Product Bulletin # CDS-011 Rev 3

# CDS Link Tilt operations with Stabilizer Kit and Coupler Plate Mount

Figure 1: CDS link tilt assembly

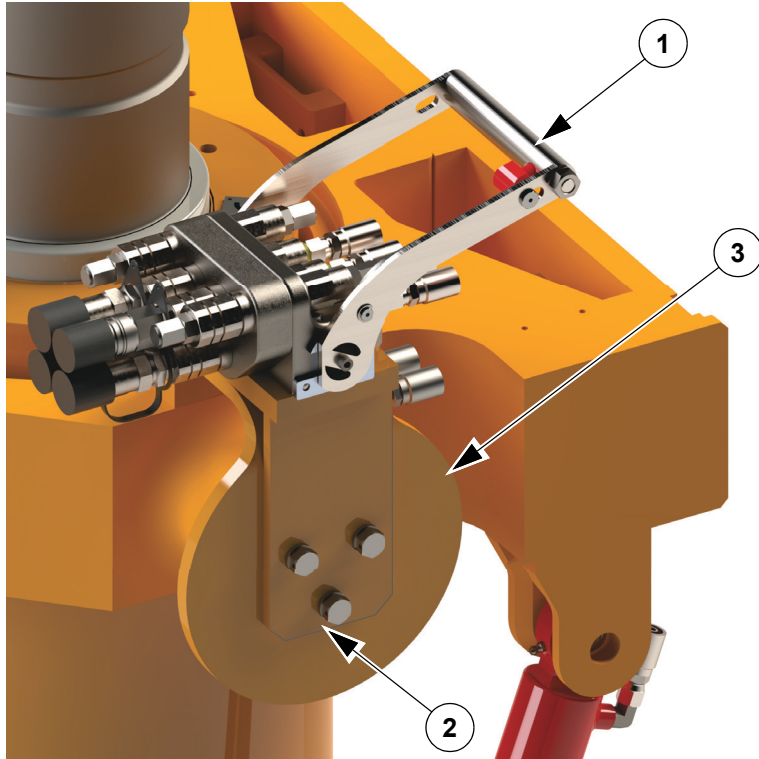
1. Disassemble Single Joints Links Stabilizer Kit #5104015 from the CDS Link Tilt Assembly.
2. Disassemble the Multi Coupler Plate #H16763 (1), Mount #DT24294 (2) and Guard #16062 (3) from the CDS Link Tilt Assembly (Driller's Side):

Figure 2: Modified mount

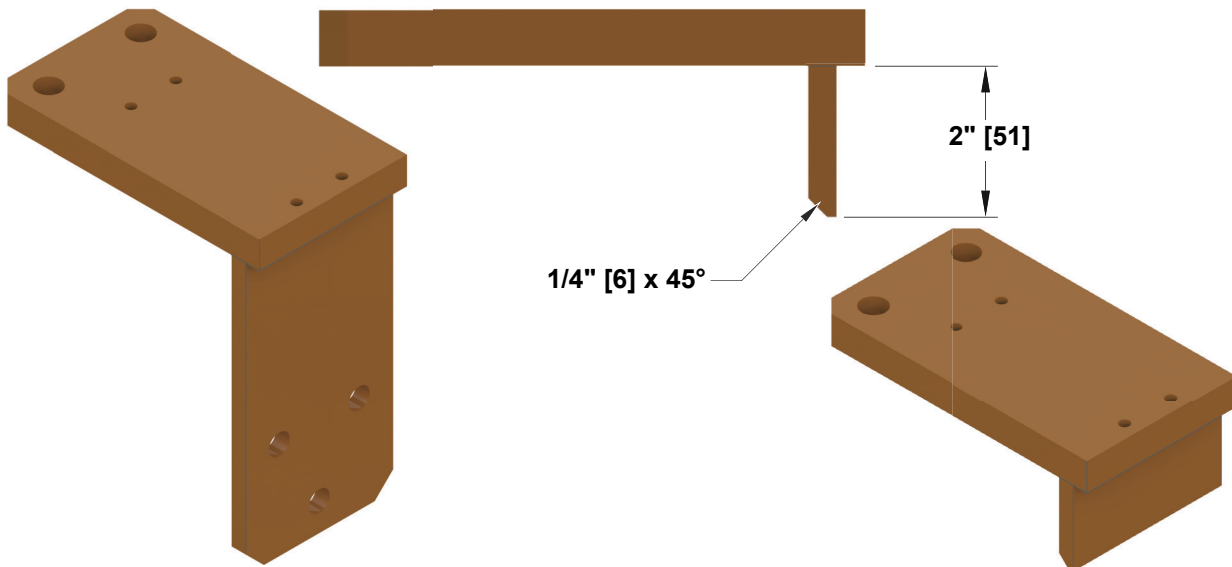
3. Modify Coupler Plate Mount #DT24294 to #DT24294M:

Figure 3: New mount weldment

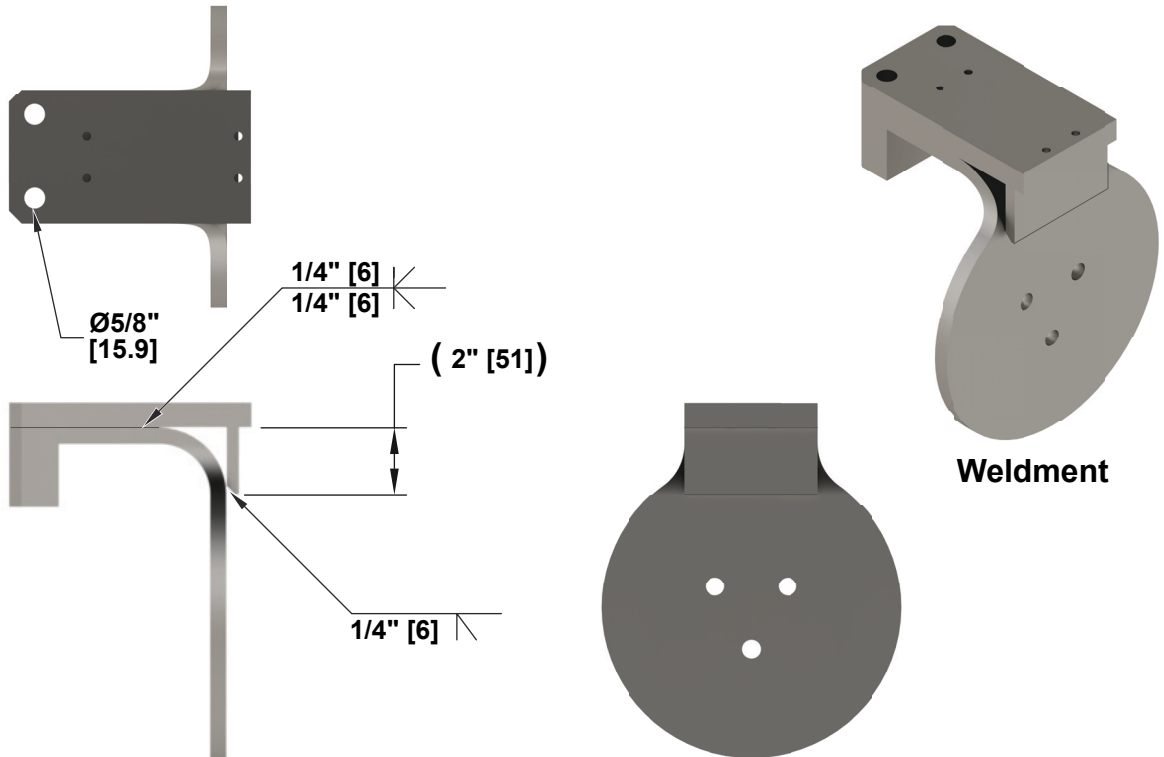
- Remove paint from modified Coupler Plate Mount #DT24294M and Guard #16062 and prepare for welding.
- Weld the modified Coupler Plate Mount #DT24294M to Guard #16062; Ensure the components' two (2) 5/8" holes are aligned:

Figure 4: Mount Painted

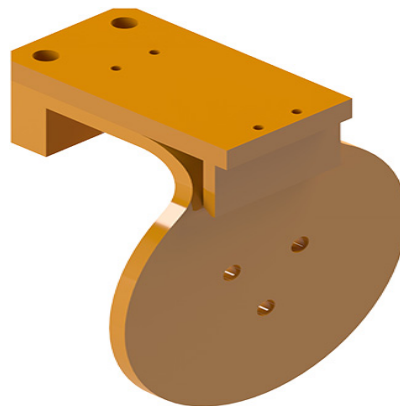
- Paint the modified Guard #16062M (c/w welded modified Coupler Plate Mount #DT24294M) Tesco Yellow as per ENG713.

Figure 5: Guard and kit assembled to link tilt

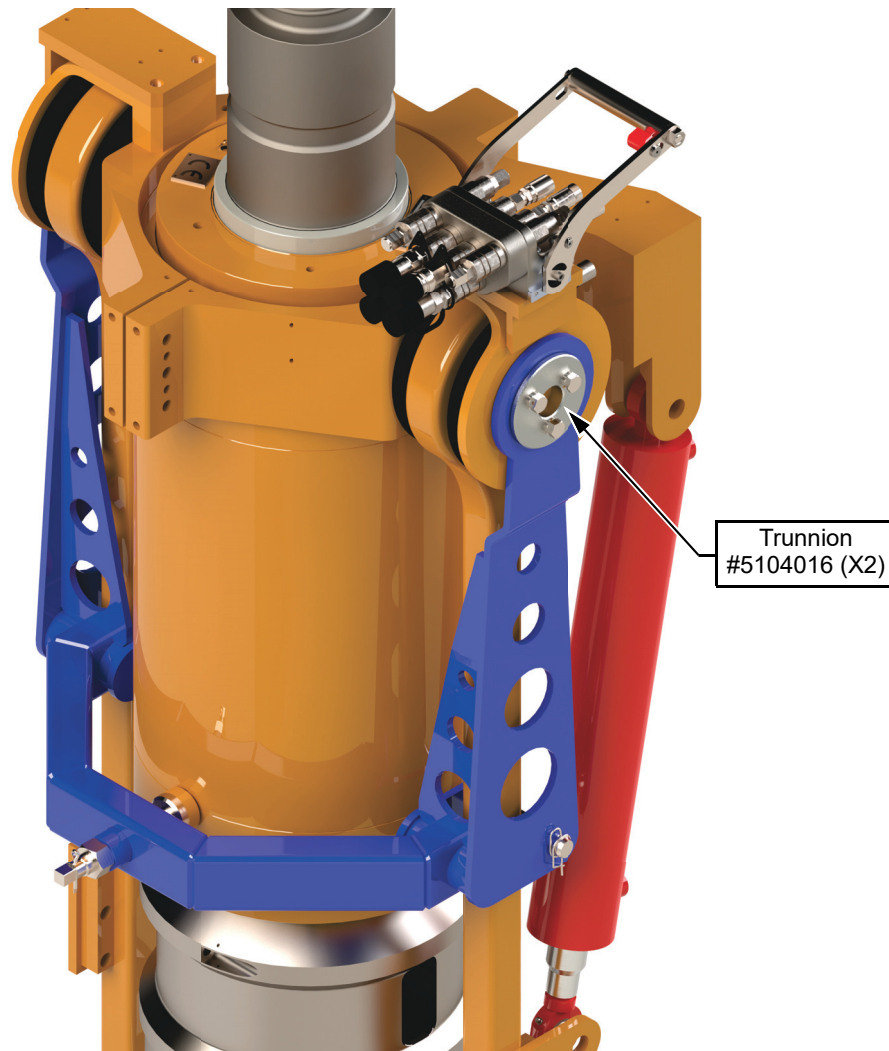
7. Install the modified Guard #16062M & H16763 Multi Coupler Plate to the CDS Link Tilt Assembly.
8. Re-install Single Joints Links Stabilizer Kit #5104015 to the CDS Link Tilt Assembly:

Use #9012 Hex-Head Cap Screws, 1/2"-13 UNC × 2-1/4", Gr 8, Pld, Drilled Head (or equivalent) and Washers #5033127 to mount Trunnions #5104016. Torque the screws to 80 ft-lb and secure with lock wire.

Figure 6: 5105106 Brace

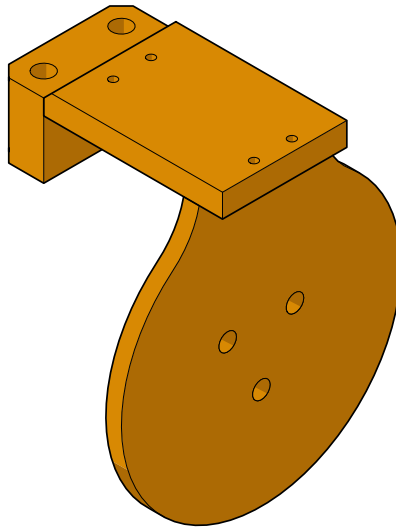
Mount #DT24294 (Qty. 2) and Guard #16062 (Qty. 3) may be replaced by ordering and installing the current Brace #5105106.

- Screws #16327 (Qty. 2), Washers #17609 (Qty. 2).
- Screws #9012 (Qty. 3)(or equivalent) & Washers #5033127 (Qty. 3) to mount Trunnions #5104016.

Torque the screws to 80 ft-lb and secure with lock wire.
